E4445A-19

S E R V I C E N O T E

E4445A - PSA Series Spectrum Analyzer

Internal Alignment Failures for PSA Series Spectrum Analyzers Manufactured Between January 2004 and February 2006 Caused by Low Power Output from A9A1 DRO on A9 Second LO Assembly

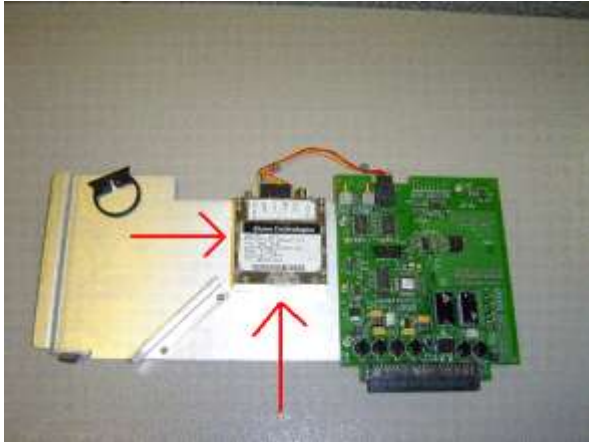
Verify the alignment failure by looking at the error queue for the error message “-340, Calibration failed, Align_2ND_LO_PWR”. Press [System] <Show Errors> <Next Page>. Typically, when the Second LO power is too low, it will be the first failure listed in the alignment queue, which will be at the bottom the Second page of alignment errors (as shown below):

Replace just the DRO by removing it from the Second LO assembly and replacing it with a new one.
